**In Re: Docket No. 388, Application of New Cingular Wireless PCS, LLC (AT&T) for a Certificate of Environmental Compatibility and Public Need for the construction, maintenance and operation two telecommunications tower facility located at 1990 Litchfield Turnpike.**

I write today to present the Connecticut Siting Council with my opinion that the above-captioned proposed facility is not the least visually detrimental to the Connecticut environment surrounding the proposed facility site. I am working on behalf of the Woodbridge, Connecticut Conservation Commission.

# Wireless Attachment to Transmission Tower

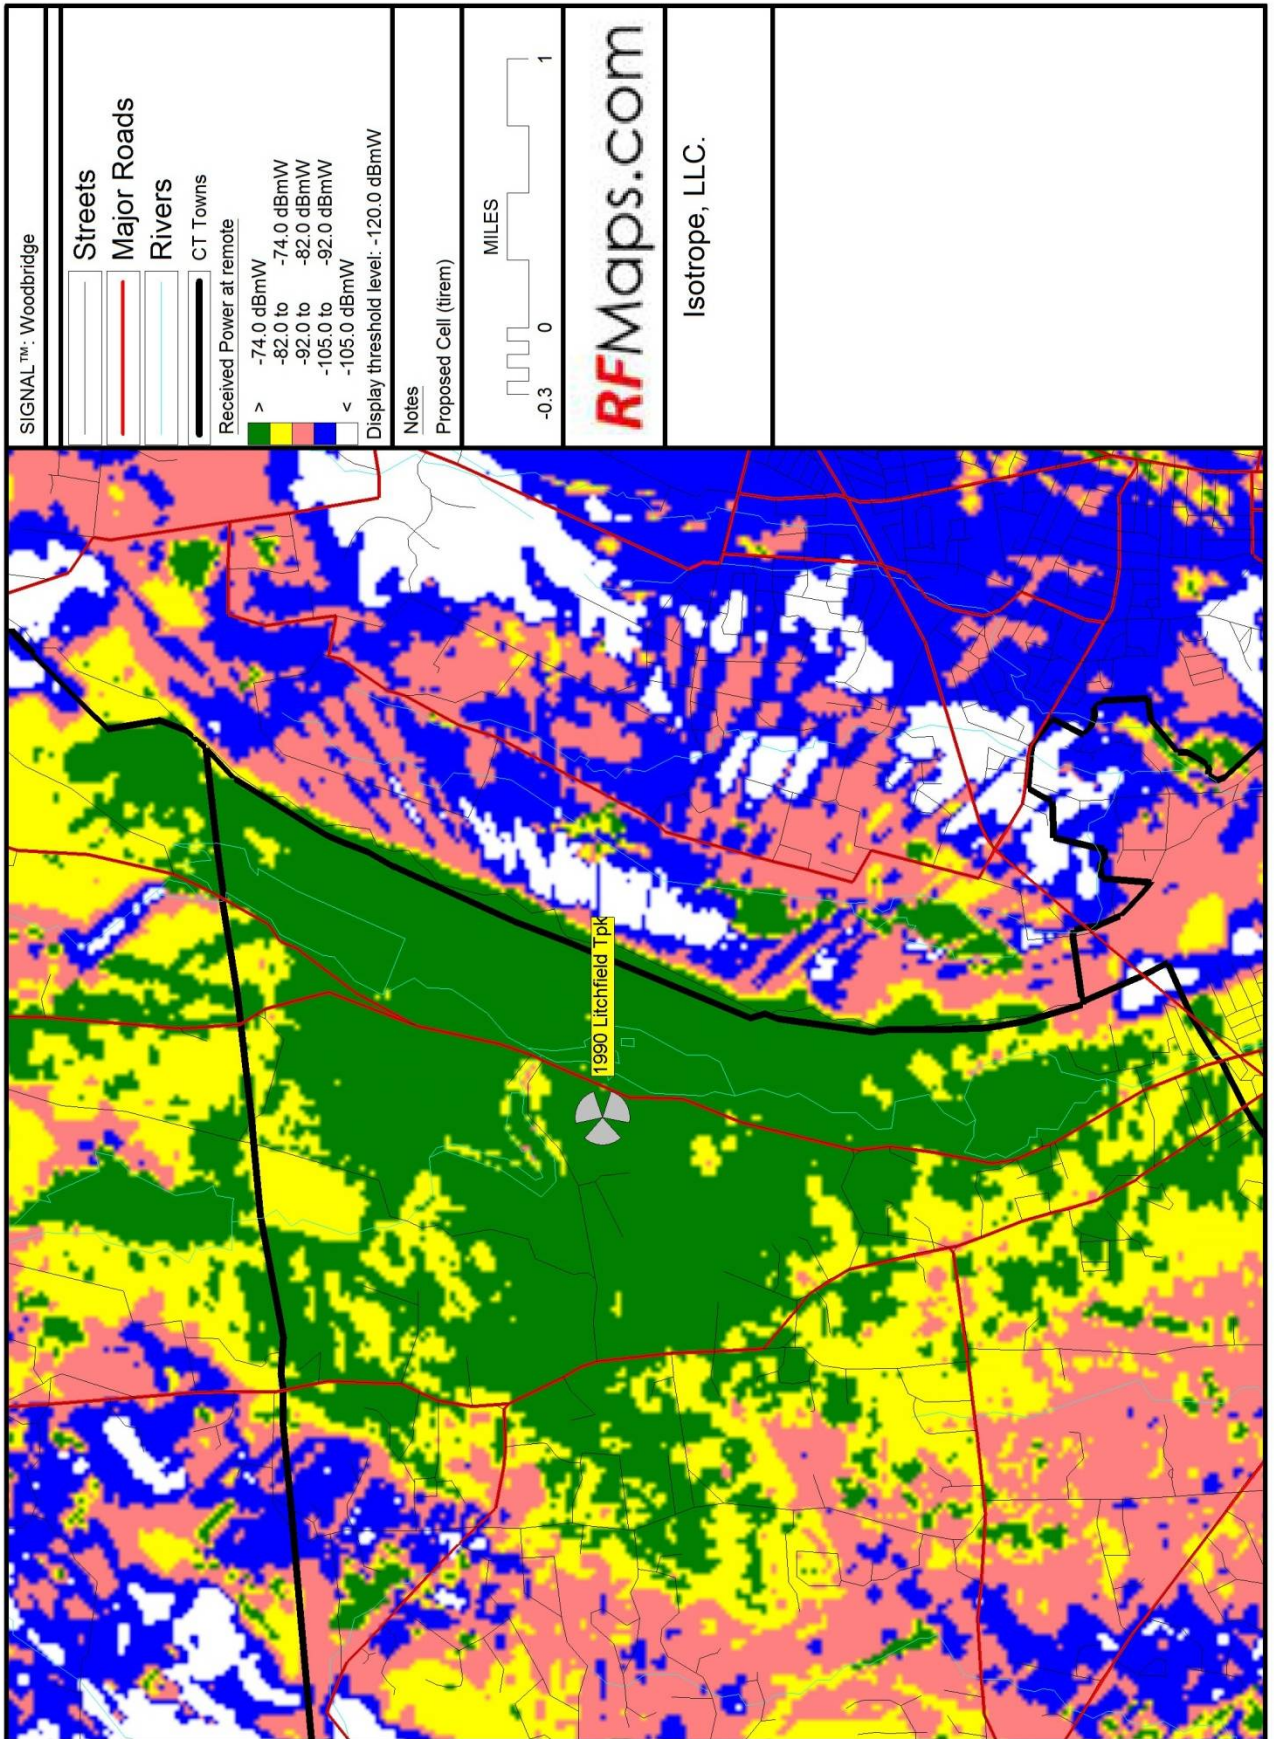
Also, we suggest that since transmission tower replacement is not necessary, the duration of outage for an attachment would be significantly less than for a replacement. With suitable engineering, and if necessary, reinforcement, existing steel transmission towers are often retrofitted with wireless antennas. Outage time and construction cost would be significantly reduced with a retrofit attachment instead of a replacement. For illustration I have appended a photograph of a wireless three-sector antenna canister mounted on the top of a transmission line tower in Barnstable, Massachusetts. This photograph is marked Exhibit 2 and is incorporated herein by reference.
